Product Change Notice

Issue Date: 16 May 2005

To add an alternate source for epoxy encapsulate

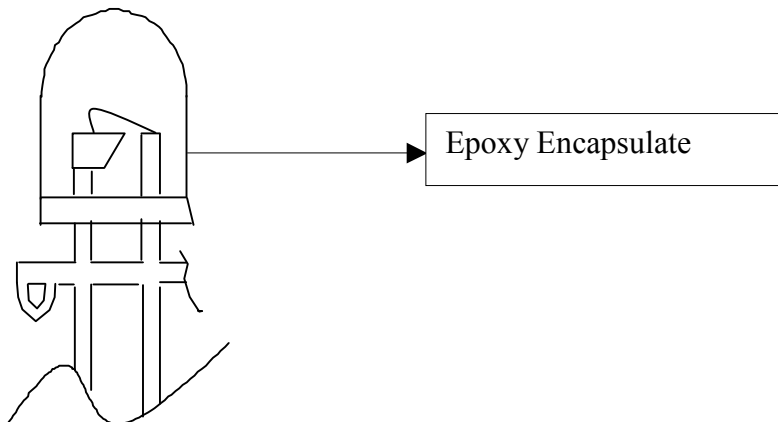
To add an alternate source for the epoxy encapsulate illustrated in the above figure.

Qualification and characterization has been done for this alternate epoxy encapsulate. The characterization result indicates that the alternate epoxy encapsulate has comparable performance in optical and thermal characteristics. Therefore there is no major change in fit, form and function.(Reliability data is shown in paragraph 7)
